92-515

Wizards Workshop

TEKTRONIX INTERNAL USE ONLY

November 21, 1980
Issue 10-23

7D02 FAILURE TO POWER UP (CONTINUED)

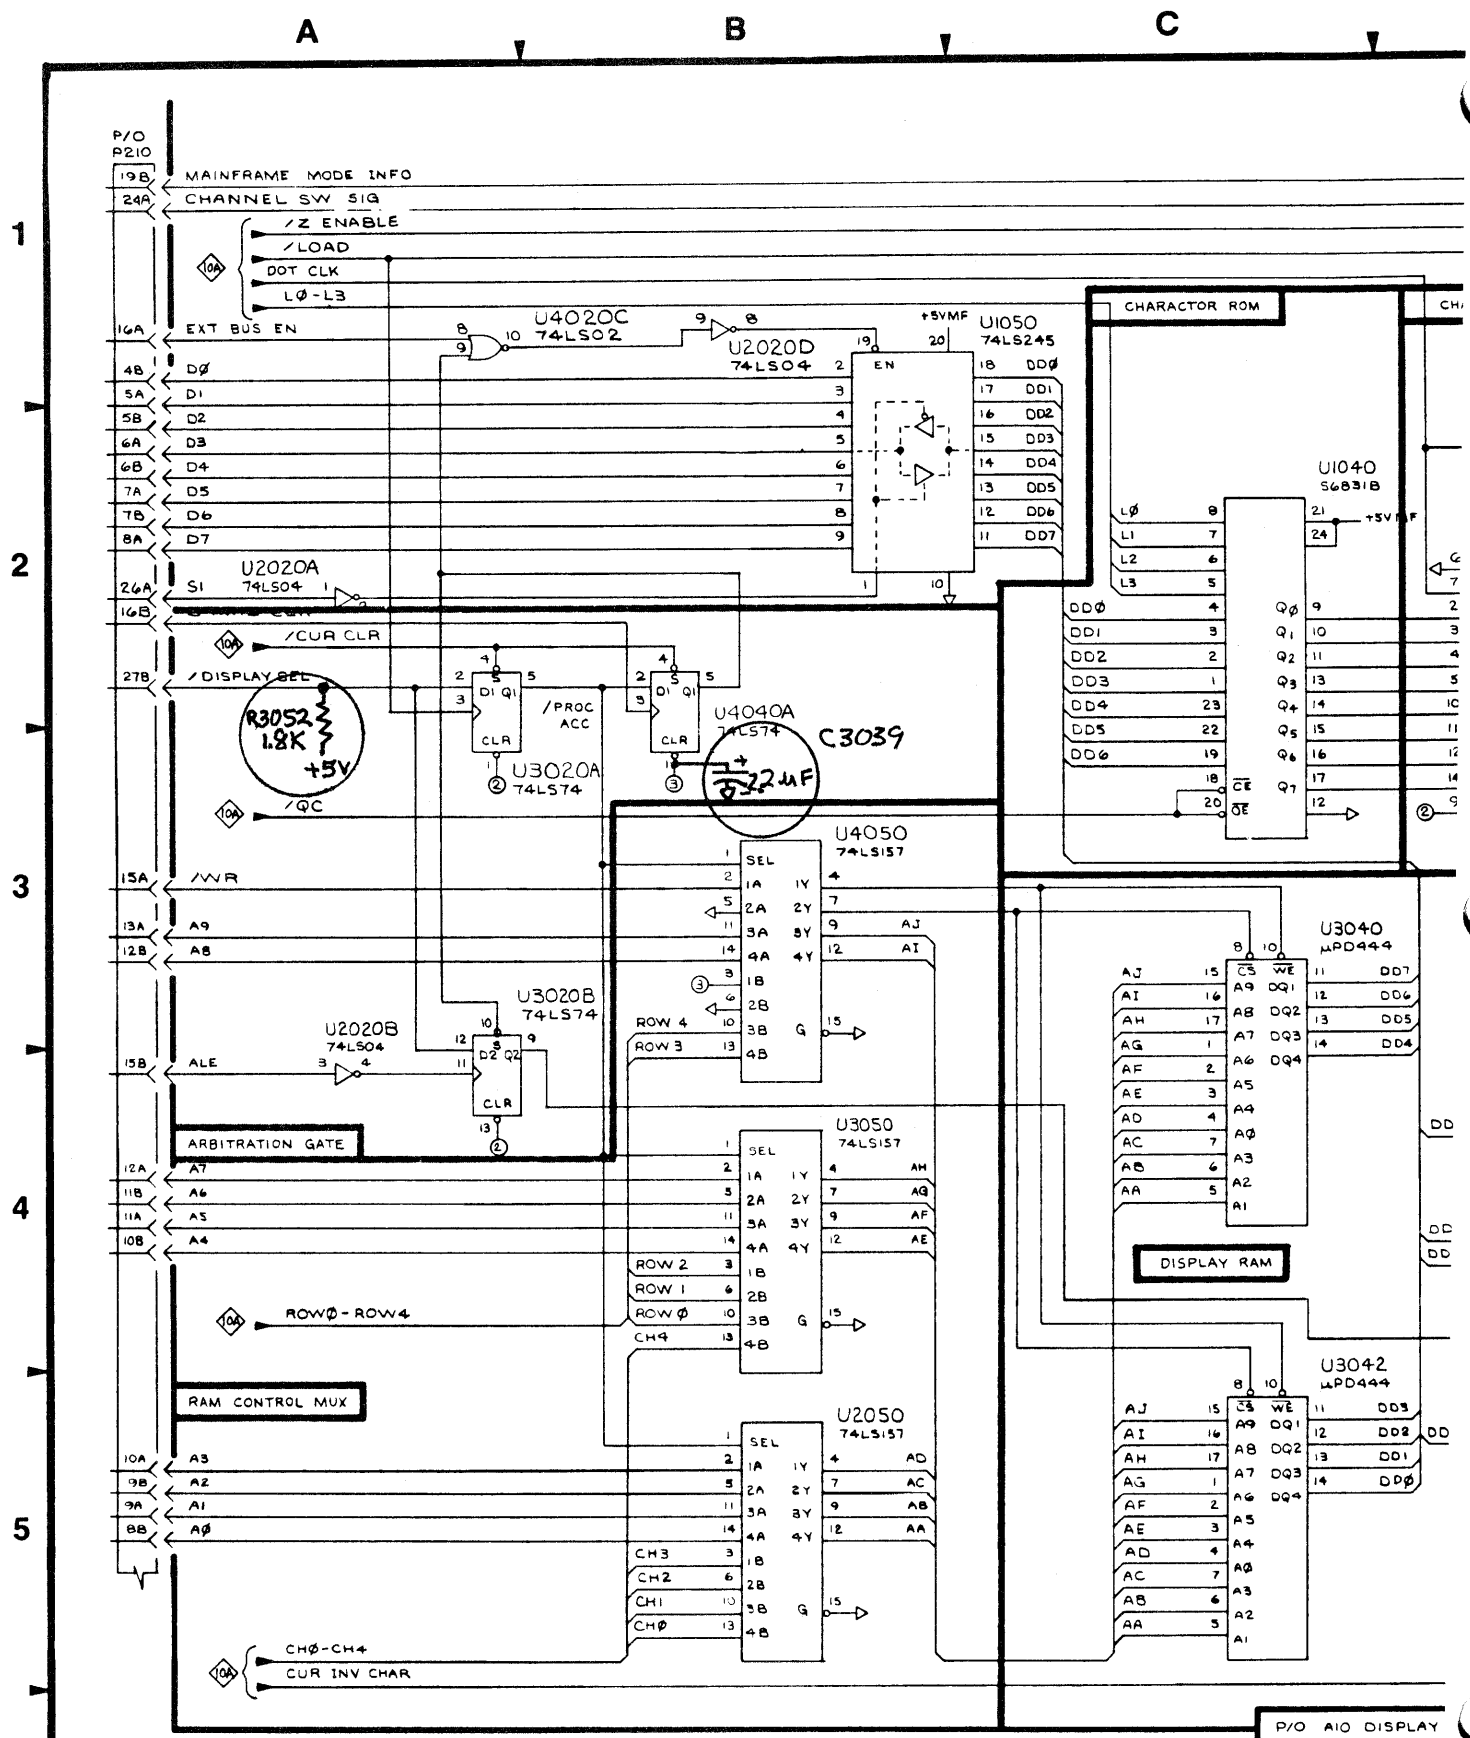
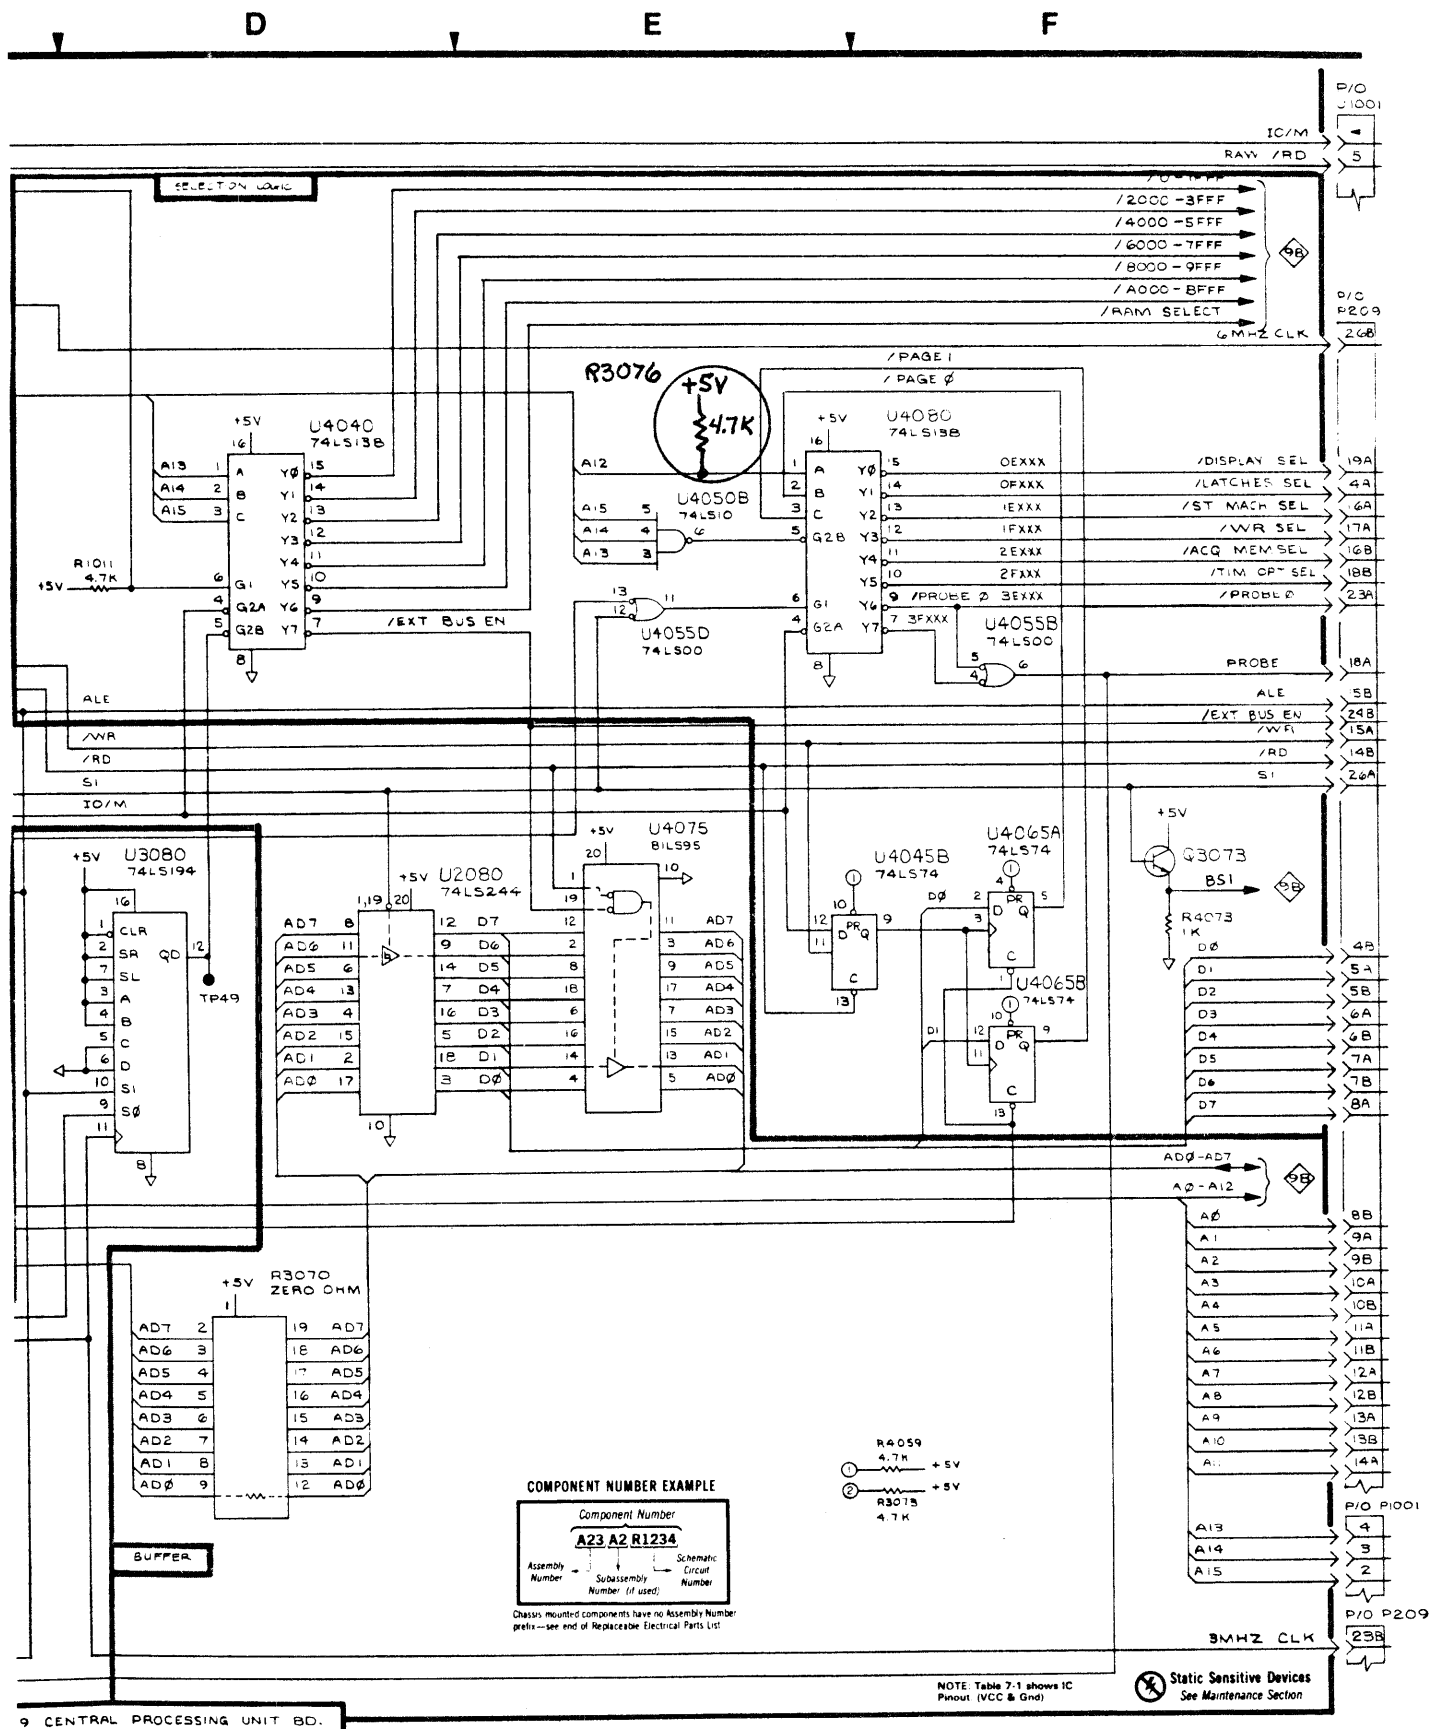
This condition is caused by the display board +5 Volt supply coming up slightly before the C.P.U. Board +5 Volt Supply. This in turn, sometimes causes the ready line to go low while the C.P.U. is trying to exercise power up routines. A low READY line will inhibit the 8085 from writing to and reading from memory.

The fix is to add a 4.7K resistor R3076 (315-0472-00) to the C.P.U. Board (670-5984-00), from U4080 Pin 1 to +5 Volts. Also, add to the display board (670-5983-00), a 1.8K resistor R3052 (315-0182-00), from U3020B Pin 12 to +5 Volts, and add a 2.2 microfarad capacitor C3039 (290-0523-00), from U4040A Pin 1 to ground.

Figure 1 4052 Manual Schematic 5-2

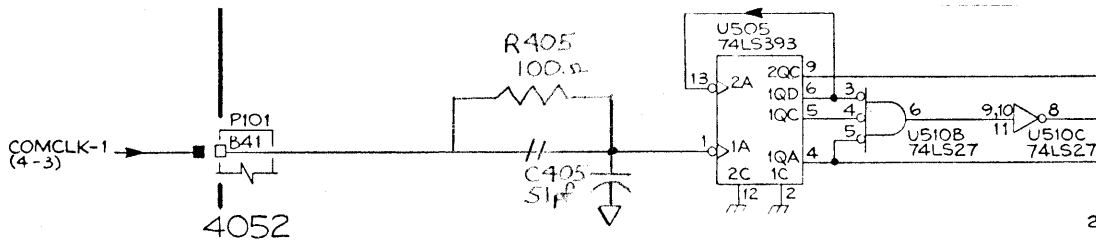
Procedure: (refer to figure 1)

- 1) Clip and lift pin 1 of U505
- 2) Add 100ohm resistor (317-0101-00) circuit number R405, between U505 pin 1 and the pad of where pin 1 of U505 was clipped from.
- 3) Add a 51pf capacitor, circuit number C405 (283-0107-00), between U505 pin 1 and ground.
- 4) The 670-5632-01 will roll to a -03.

Figure 2 4054 Manual Schematic 5-2

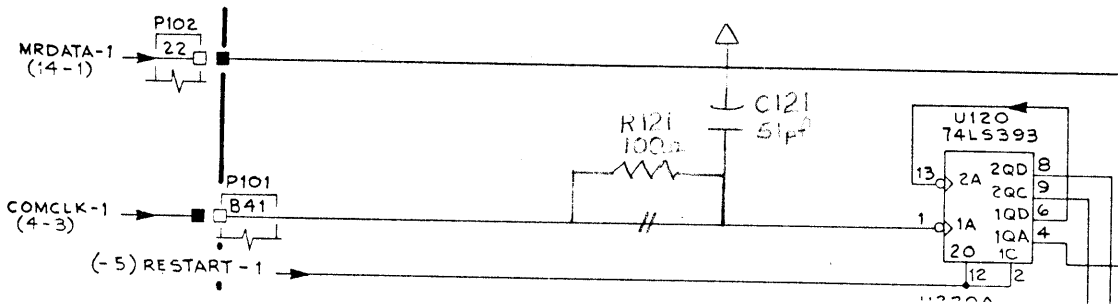
Procedure: (refer to figure 2)

- 1) Clip and lift U120 pin 1
- 2) Add 100 ohm resistor circuit number R121 (317-0101-00), between U120 pin 1 and the pad of where pin 1 of U120 was clipped from.
- 3) Add a 51pf capacitor, circuit number C121 (283-0107-00), between U120 pin 1 and ground.
- 4) The 670-5666-01 rolls to a -02.

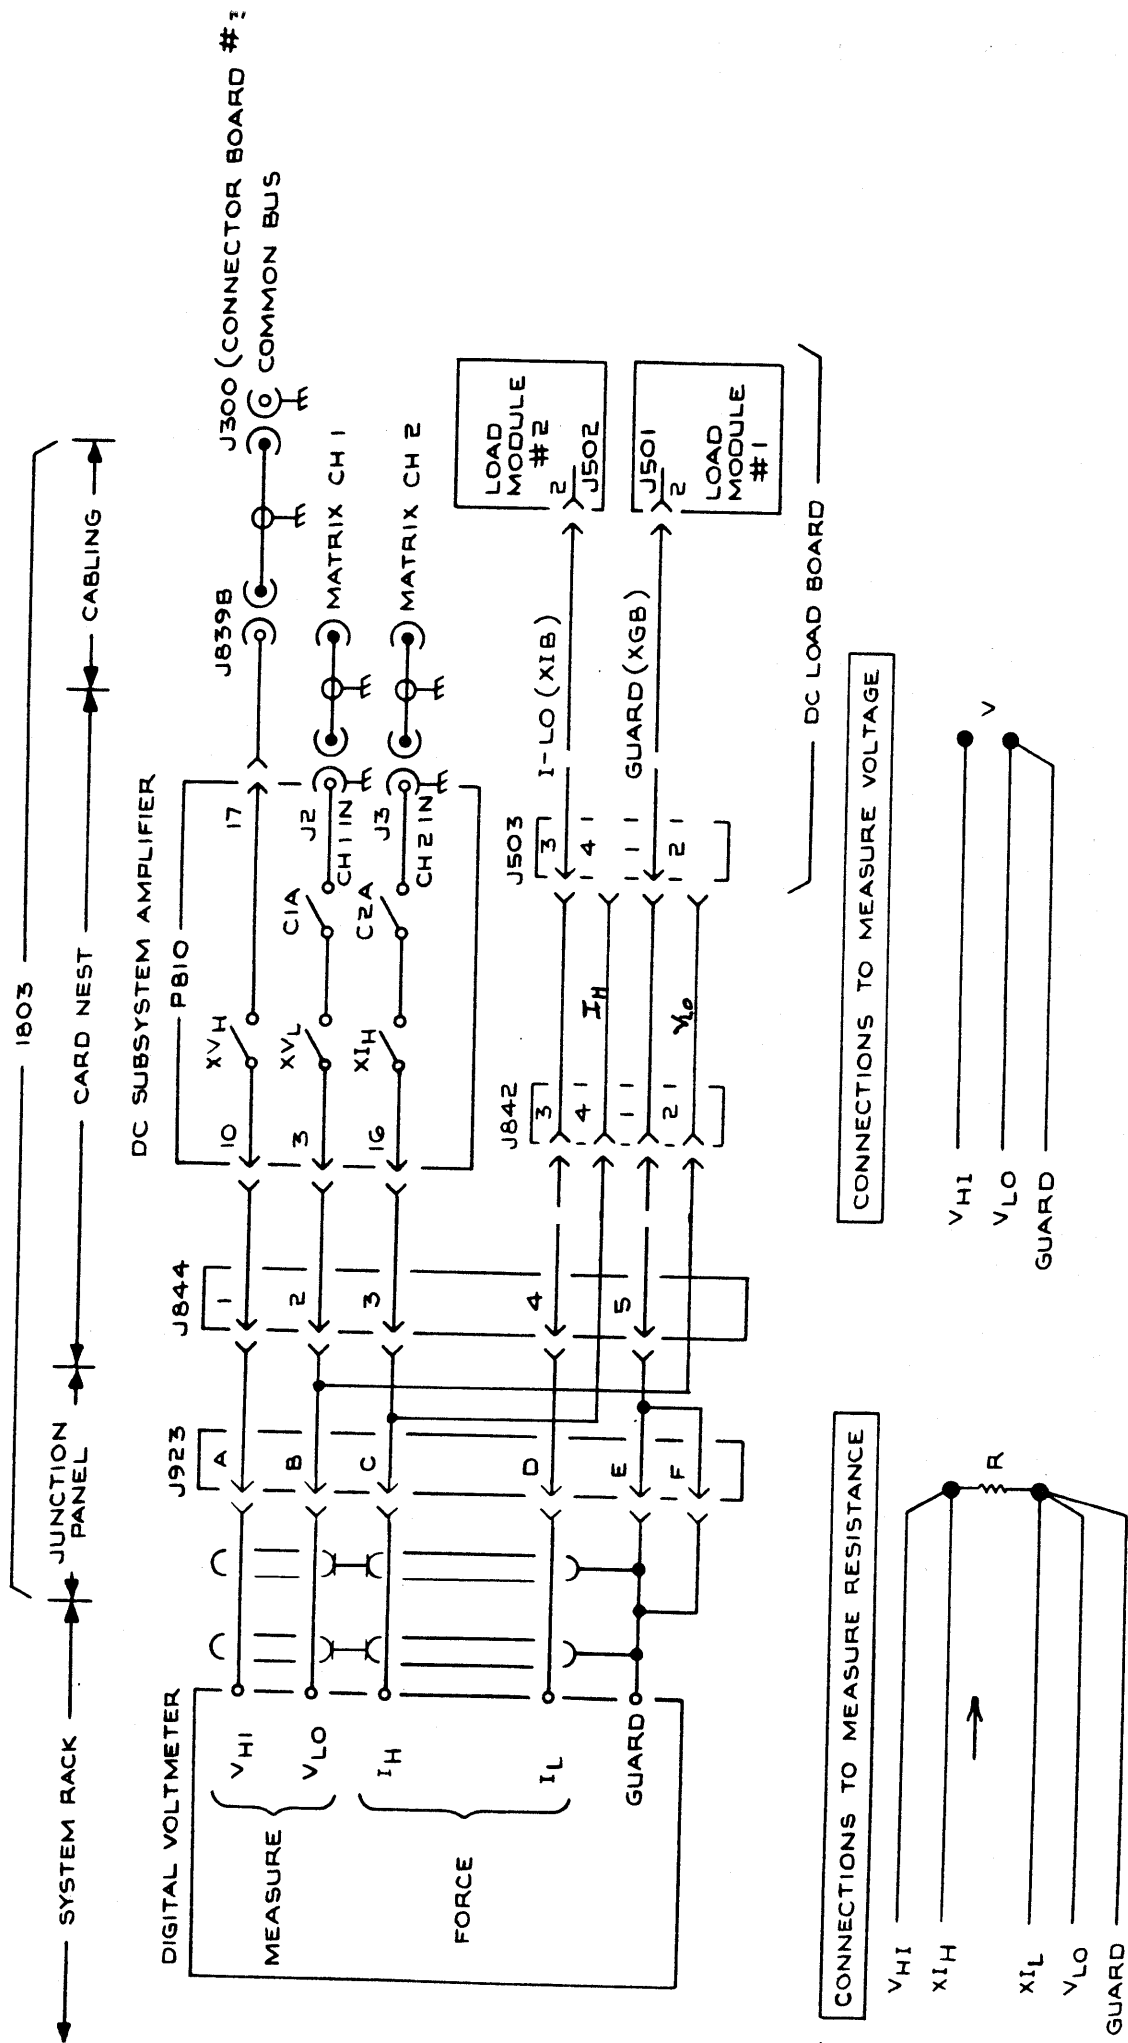
The DC Load Circuit board (670-2831-03) must have the runs cut between J503 Pins One and Two. The runs between Pins Three and Four must also be cut. These connections are shown in 070-3291-00 manual "Program Controlling the Fluke 8500A DVM" Figure Diamond 2, cabling, DVM to 1803.

The new DC load circuit board 670-2831-04 directly replaces the 670-2831-03.

The attached drawing details the new signal paths for the Fluke DVM. Note the new signal paths for Ih and Vlo from Junction Panel J923 to cardnest J842 for the 1803 Test Station. Cable part number 179-2087-02 is necessary for these signal paths to be complete when used with the 670-2831-04 DC Load Board. This cable is also used with Type J Fixturing.
